YESTER OAKS SHOPPING CENTER SUBDIVISION

APPLICATION NUMBER 10 DATE August 8, 2013
 APPLICANT Yester Oaks Shopping Center Subdivision
 REQUEST Subdivision

DETAIL SITE PLAN

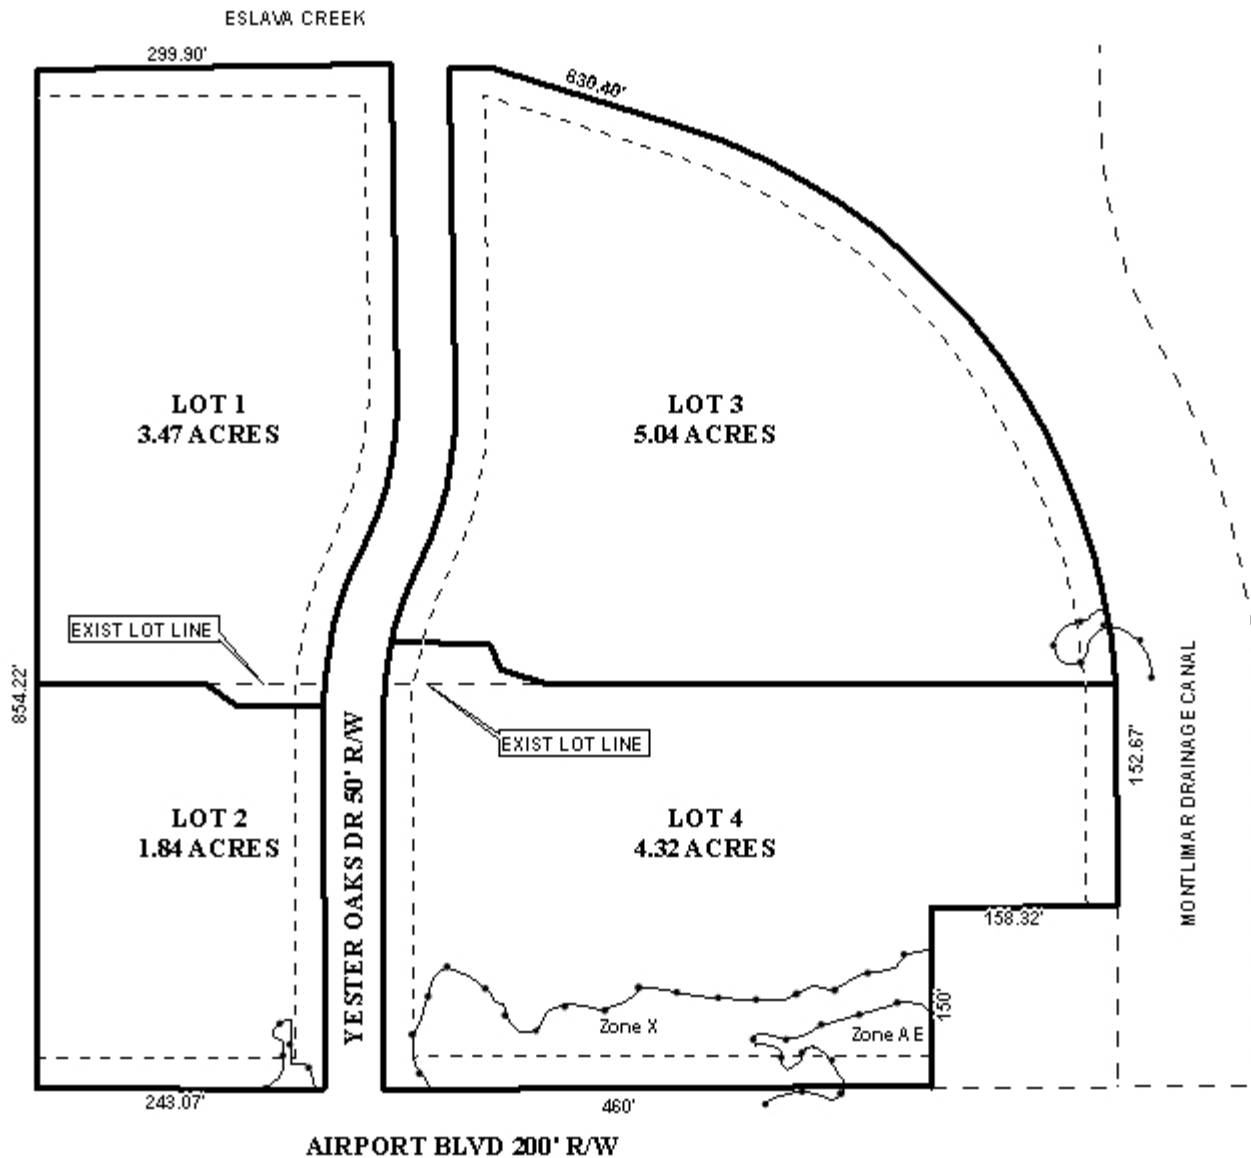
6. Show the Minimum Finished Floor Elevation (MFFE) for Lots 3 and 4 within the AE and/or X-shaded flood zones.
7. There is an existing legal action by the City (Notice Of Violation - NOV) against Lots 1 and 3. They were required to connect all existing dumpsters to the Sanitary Sewer system. A plan has been submitted and accepted by the City Engineer; however, no construction or further action has been initiated. A Land Disturbance Permit must be submitted.

The plat should be revised to indicate dedication at the Southeast and Southwest corners of Airport Boulevard/Airport Boulevard Service Road and Yester Oaks Drive, the 25' minimum building setback line should be measured from the required radius curve dedication. As on the preliminary plat, the lots should retain on the Final Plat with its size in square feet and acres, after all required dedications, or a table should be furnished on the Final Plat providing the same information.

- 1) dedication of a 25' radius curve at the Southeast and Southwest corners of Airport Boulevard/Airport Boulevard Service Road and Yester Oaks Drive;
- 2) placement of a note on the Final Plat stating that that the site is limited to the existing curb cuts to Airport Boulevard/Airport Boulevard Service Road and Yester Oaks Drive;

- 4) revision on the Final Plat to indicate the 25' minimum building setback line as measured from the dedicated radius curve at the Southeast and Southwest corners of Airport Boulevard/Airport Boulevard Service Road and Yester Oaks Drive;

- 5) retention on the Final Plat indicating the lot sizes in square feet and acres as calculated after any required dedications, or the furnishing of a table on the Final Plat providing the same information;
